**CITY OF GLENDALE
COMMUNITY DEVELOPMENT AUTHORITY
5909 N. Milwaukee River Parkway
Glendale, Wisconsin 53209**

AGENDA

To: Rachel Safstrom, City Administrator
From: Clark Dietz, Inc.
Date: February 17, 2021
Subject: Bayshore Restaurant Development Civil Site Plan & Stormwater Review Memo
Copies: Charlie Imig, Director of Public Works, Mustafa Emir, P.E. PhD, City Engineer; Todd Stuebe, Director of Community Development

SITE PLAN

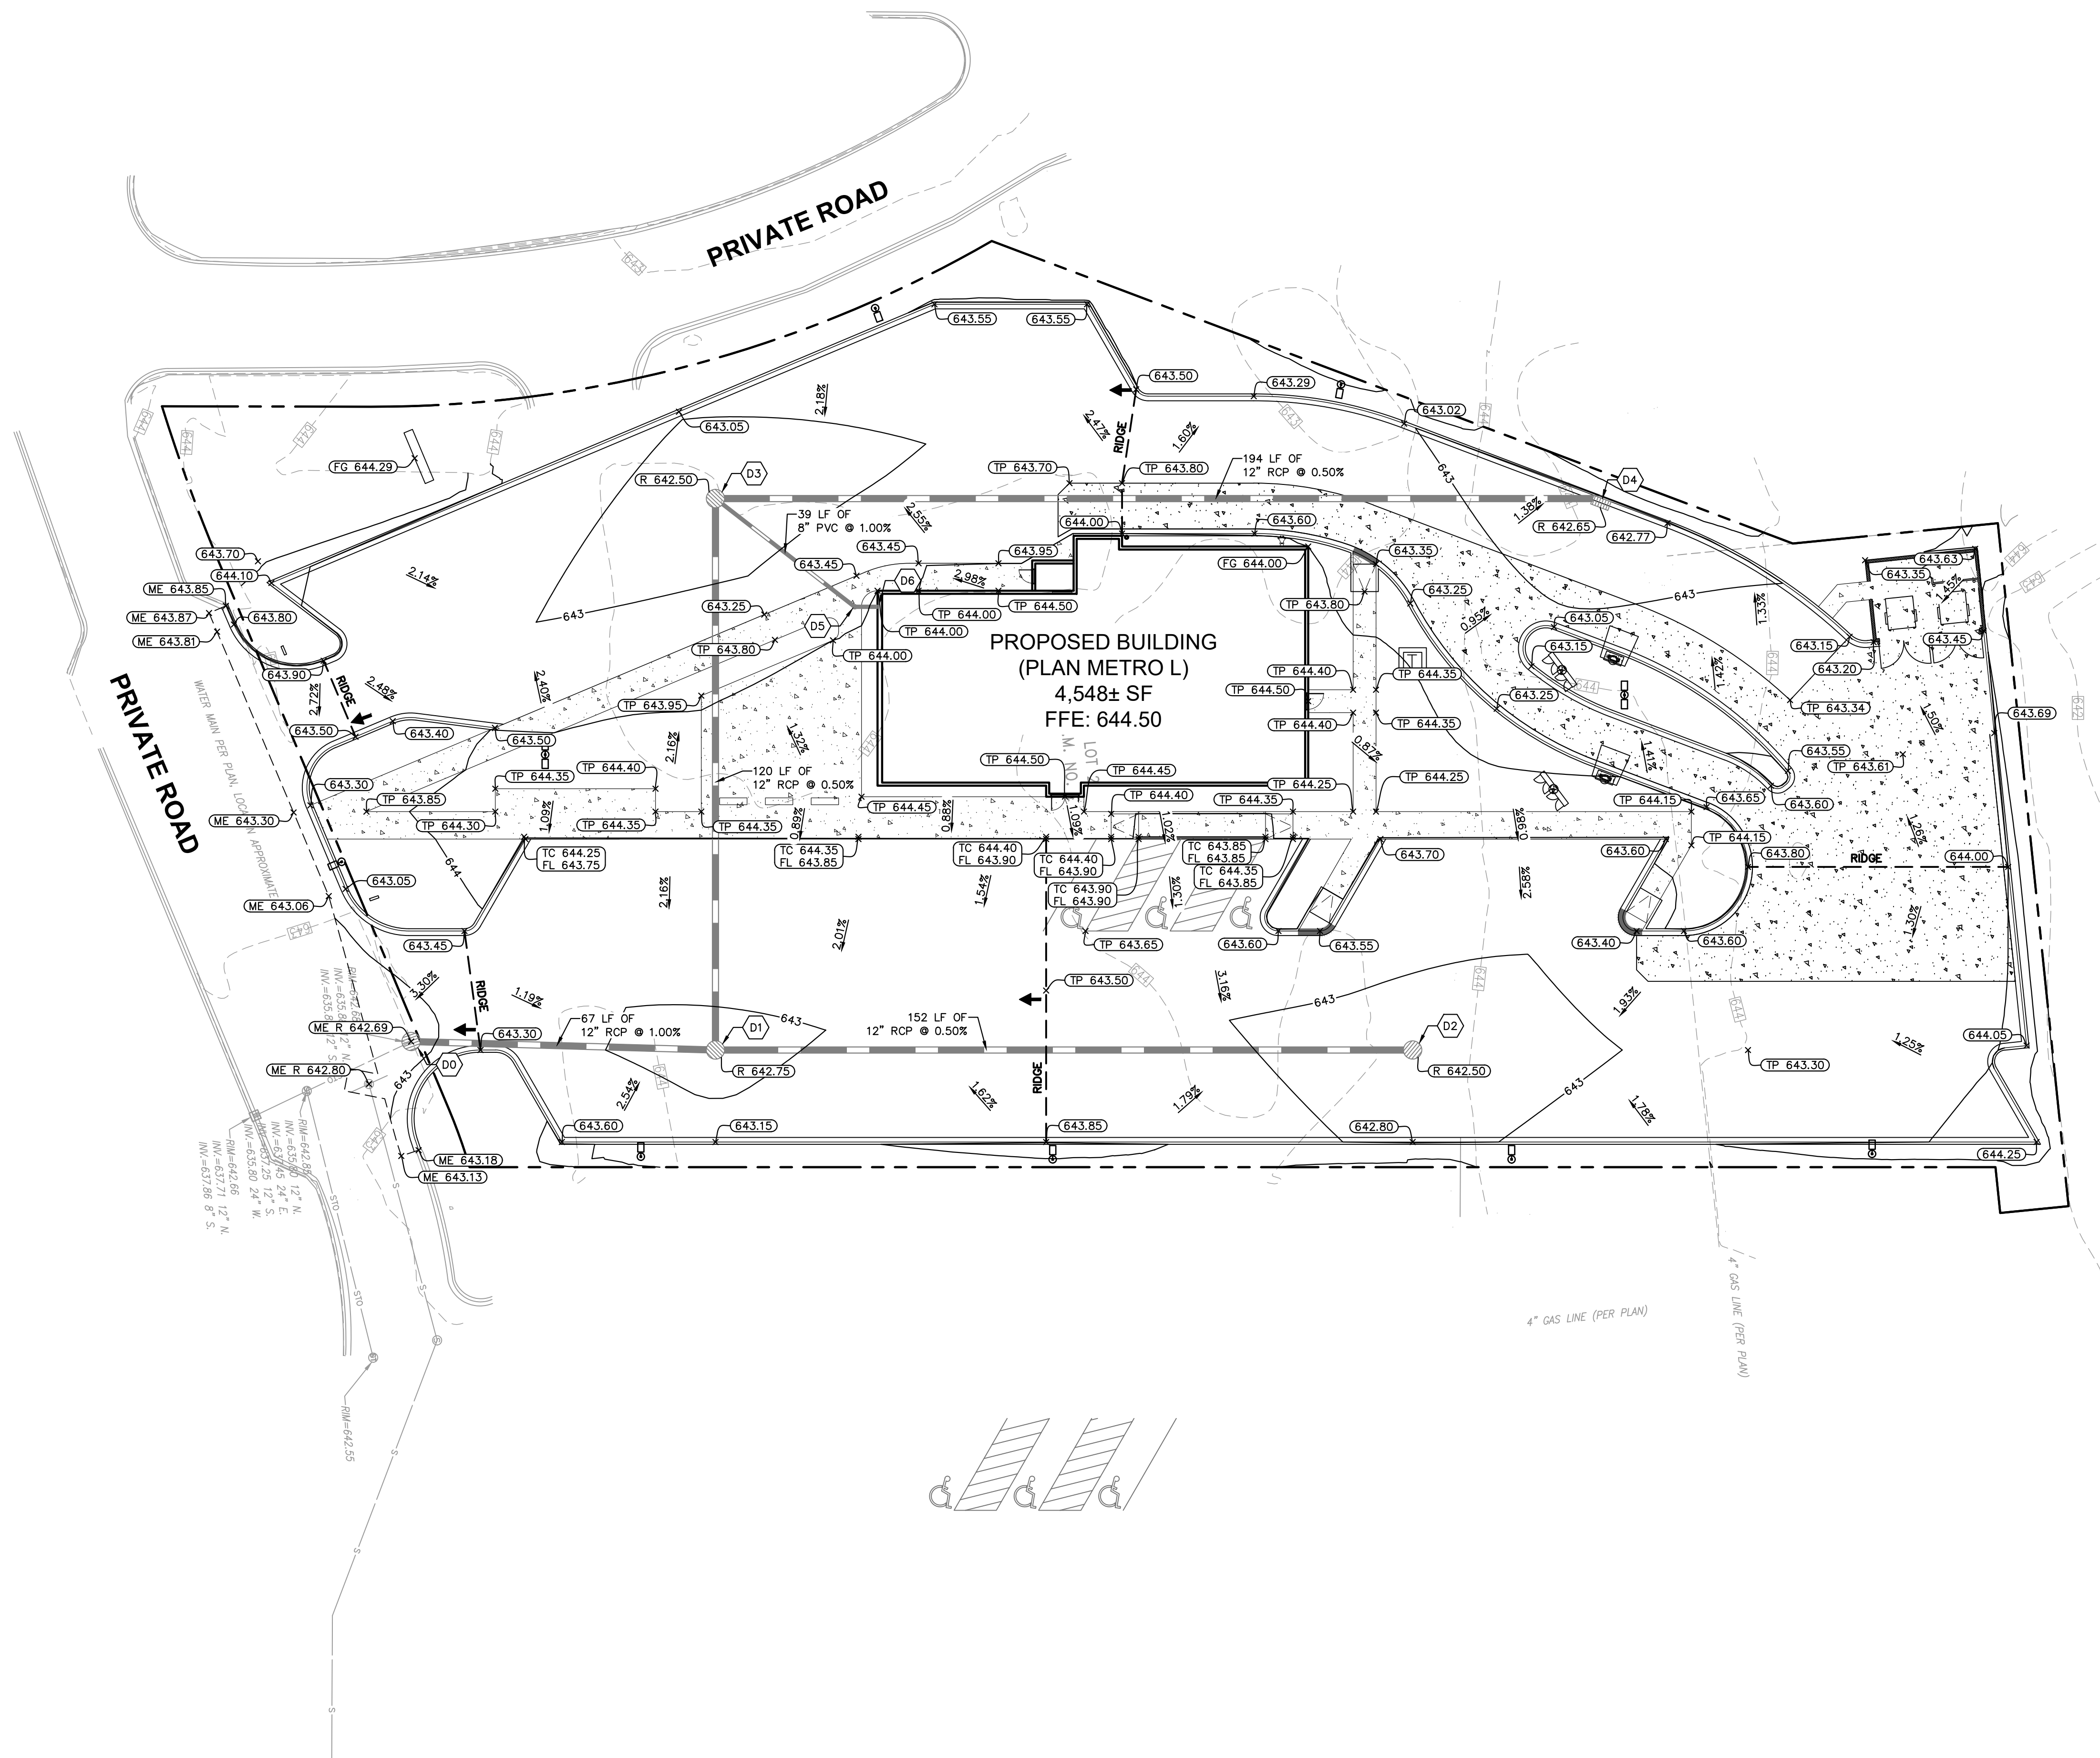
5. In looking at the plans there is a light pole, menu board, and canopy that will be very close to the raw water main. It is important that the precise boundary of the easement is known beforehand and that the contractor stays out of it.

1. Is proposed sidewalk meant to cross the street? Show accepting sidewalk or crosswalk on the plans.
2. Provide details for pavement cross-sections.

GRADING AND DRAINAGE PLAN

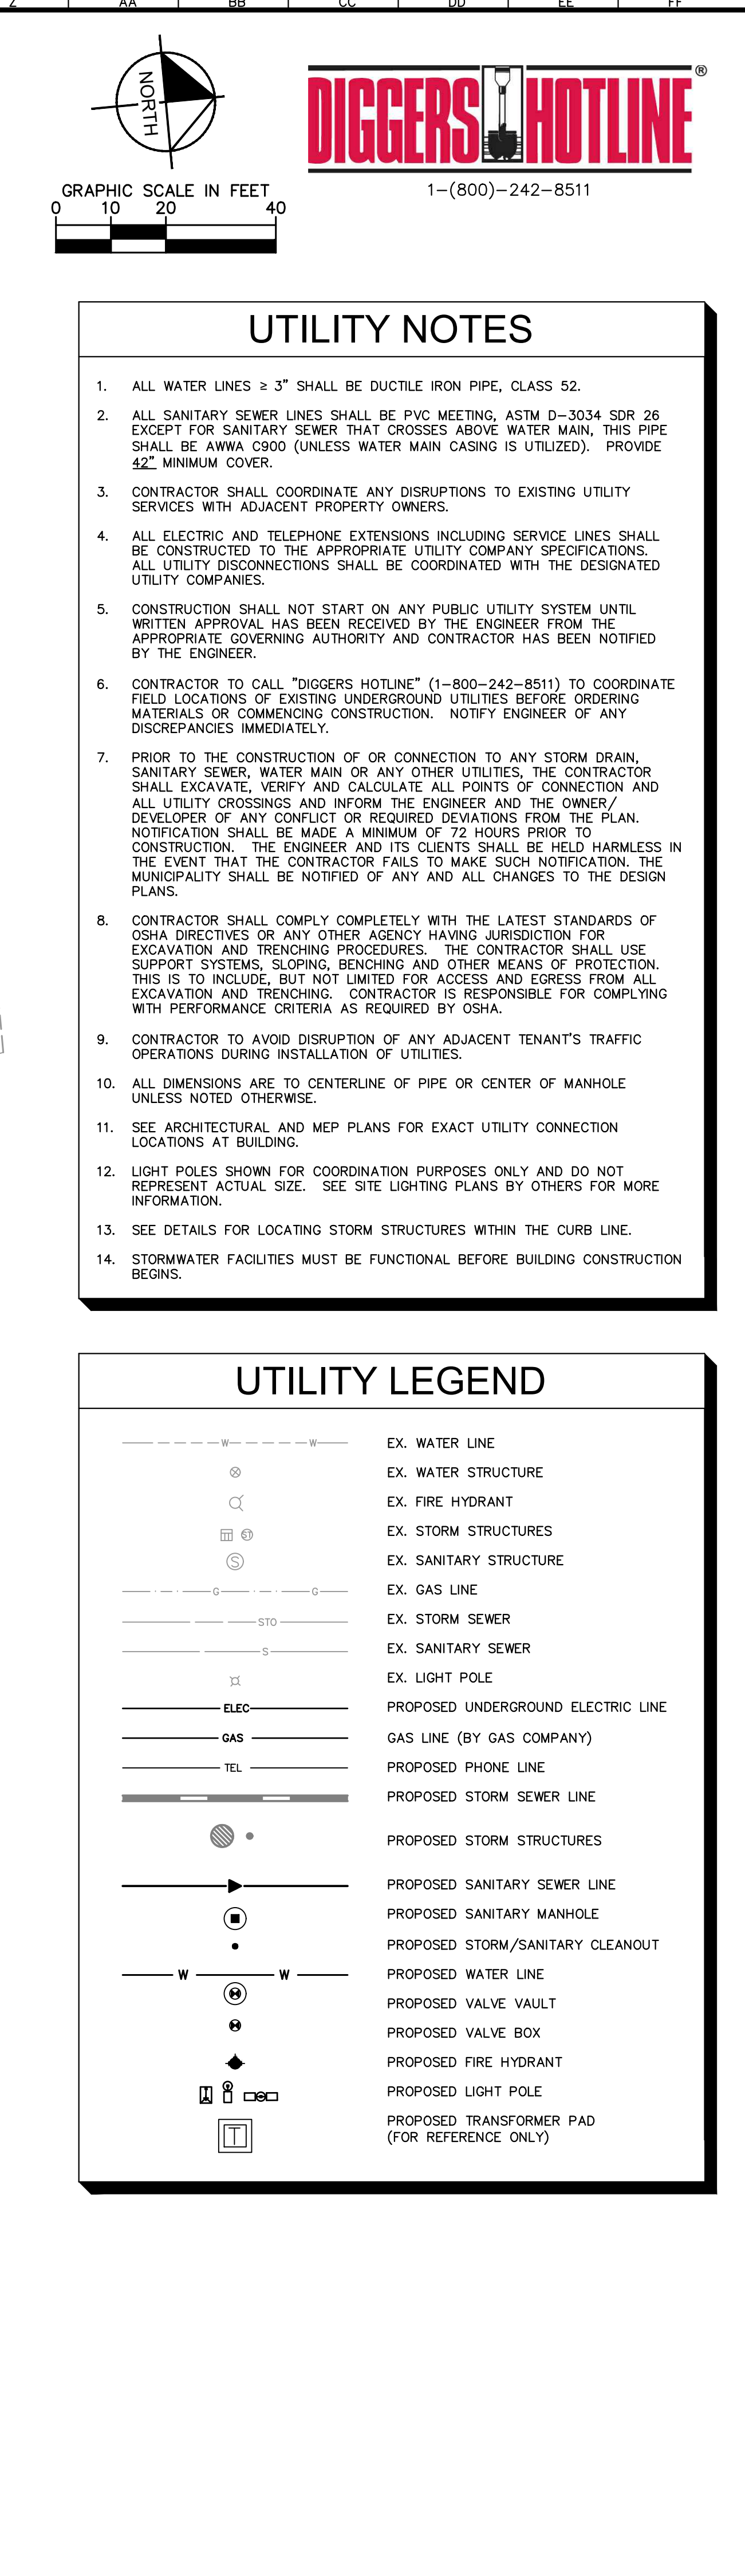
4c.1 - Show contours extending 100 feet past the property boundaries.

4h. Provide storm sewer sizing calculations that coincide with the Utility Plan. Calculations shall be provided to show the proposed storm sewer meets:

16. Provide overland flow path from the development site to a major conveyance system.
